# M A N U A L C H A N G E S

## 4328A

### MILLIOHMMETER

Model Number:	4328A
Date Printed:	JAN. 1982
Part Number:	04328-90008

Figure 5-3.  $(90\Omega + j180\Omega)$  Impedance

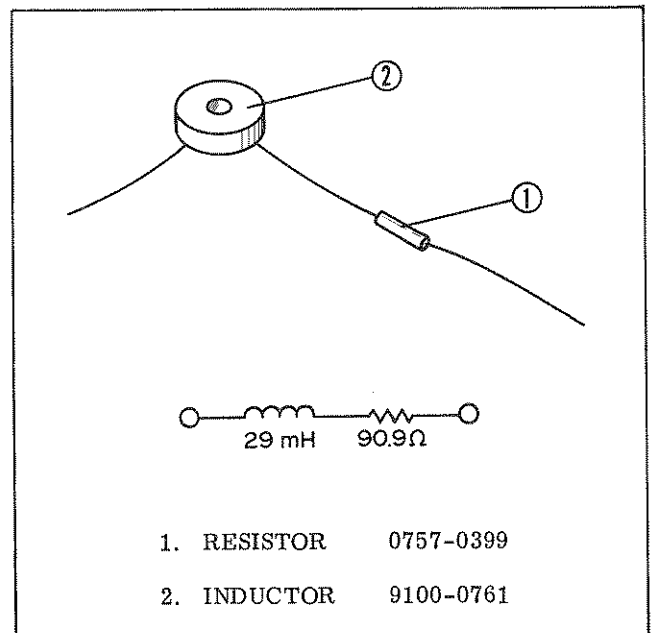
- Page 5-7, Figure 5-3, (90Ω + j180Ω) Impedance:  
 Change the Part Number for INDUCTOR to 9100-1686.

Figure 7-1. Partial Schematic of A2 Ass'y

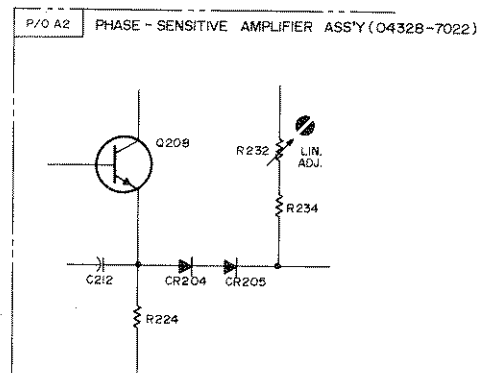
Page 8-19, Figure 8-18

Replace A2R238 with A2CR205 as shown in partial schematic Figure 7-1.

Figure 7-2. Partial Schematic of A3 Ass'y

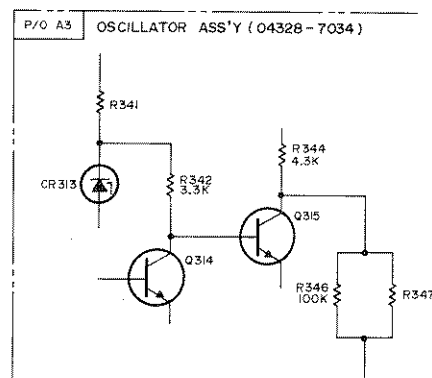
Page 8-17, Figure 8-14

Change a part of A3 schematic as follows:
